Interactive comment on “Groundwater flow and storage within an alpine meadow-talus complex” by A. F. McClymont et al.

Following are our responses to the points raised by Reviewer 2. Pages, figure and line numbers are for the original manuscript. Some revised figures are attached. Revised figure captions are below.

REVIEWER 2 (O. Sass)

Fig. 1. Figure 5

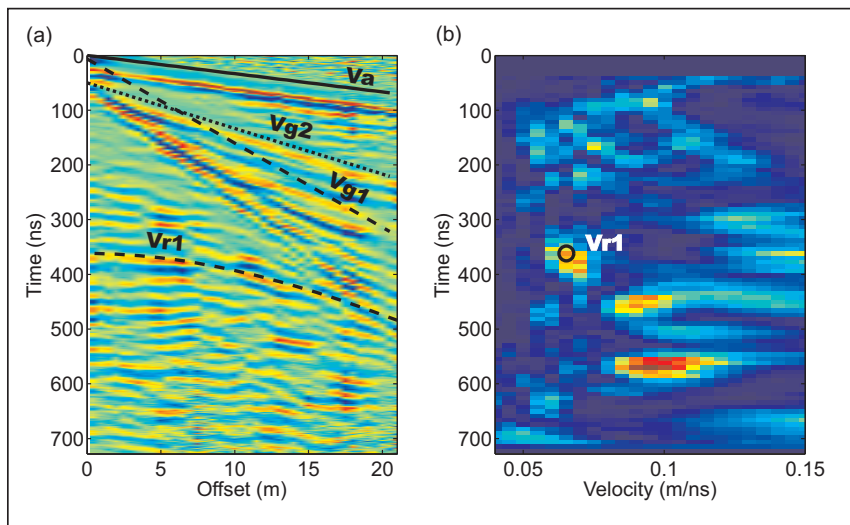
3. We have reanalyzed our CMP data. We were able to gain some useful new insights on the subsurface velocity structure from one CMP (CMP1). We now incorporate this information in the form of a new figure (Figure 5), which shows the CMP data with a full semblance analysis and in the form of new text:

"Apart from CMP1, most of the CMPs analyzed were located either on talus, bedrock, or the margins of the meadow area (Figure 3a). They yielded velocities of around 0.12 ± 0.01 m/ns, which are typical for loose debris comprising talus deposits and indurated bedrock material (Annan, 2005; Sass, 2006). Although data from CMP1 are somewhat noisy, analysis of a relatively long-wavelength groundwave arrival phase (Vg1) and a single reflection phase (Vr1) reveals a much slower velocity that is more representative of the moist fine-grained soil layer underlying the meadow (0.065 m/ns; Figure 5). A second groundwave phase (Vg2) with a shorter wavelength and a faster picked velocity of 0.12 m/ns appears to originate at around 50 ns (Figure 5). We interpret Vg2 to result from a subsurface refractor of quartzite bedrock beneath the meadow. By assuming a simple two-layer refraction model with a horizontal interface, we can solve for z, the thickness of the soil layer (Kearey and Brooks, 1991):

$$z = t_i * v_1 * v_2 / 2 * \sqrt{v_2^2 - v_1^2}$$
 (Note that this equation has been reformatted for the plain text version posted in the discussion forum)

where t_i is the zero-offset intercept time (50 ns), v_1 is the velocity of the soil layer (0.065 m/ns), and v_2 is the velocity of the bedrock refractor (0.12 m/ns). Based on our analysis, we calculate that the bedrock beneath CMP1 is no deeper than about 1.9 m."

Fig. 2. Figure 7

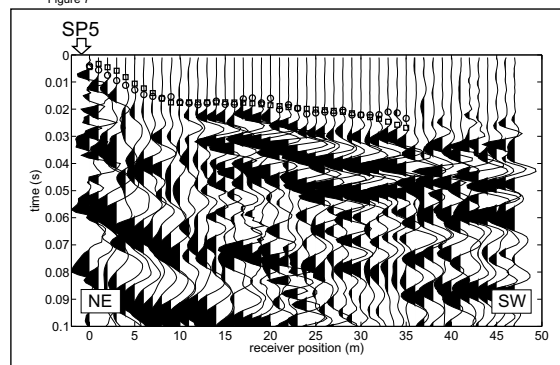
5. The two velocity phases we describe were identified on shot gathers and not on the seismic tomogram. To clarify this point, we have included an extra figure showing an example shot gather recorded on the talus (Figure 7) and cite it in the following sentence in section 4.3:

"First arrival picks from shot gathers recorded on the talus show two distinct velocity phases: 1) a slow shallow phase with velocities of around 500 m/s associated with the talus cover and 2) a faster deeper phase with velocities of around 3500 m/s, indicating a change to higher velocity bedrock (e.g. Figure 7)."

In the resulting seismic tomogram, velocities representative of bedrock have a wider range of values (2000-4000 m/s) because of smoothness constraints used to invert the data. We also include the following sentence in section 4.4 to justify why we have not used the seismic data to evaluate the depth to bedrock beneath the meadow:

Fig. 3. Figure 6

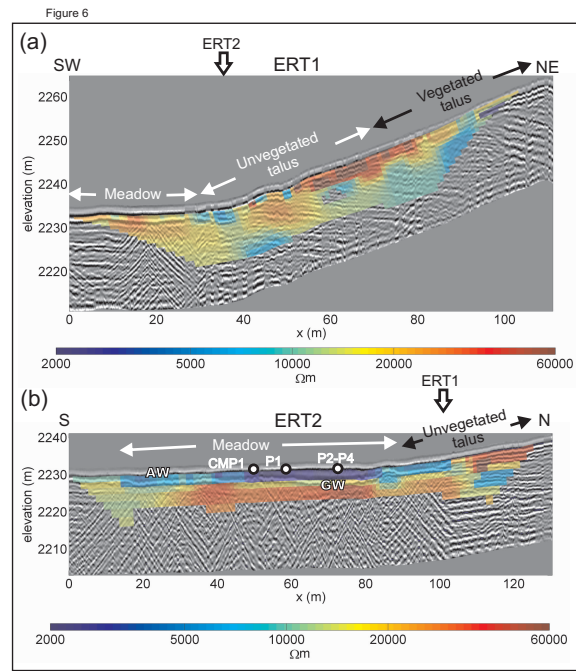
4. We address the reviewer's concerns about the spatially restricted 20-60 kohm zone

"Although the bedrock resistivities are much higher beneath the meadow than beneath the talus deposit, we do not interpret a change in bedrock composition and suggest that the high values are a consequence of overfitting the inverted resistivity data in this region."
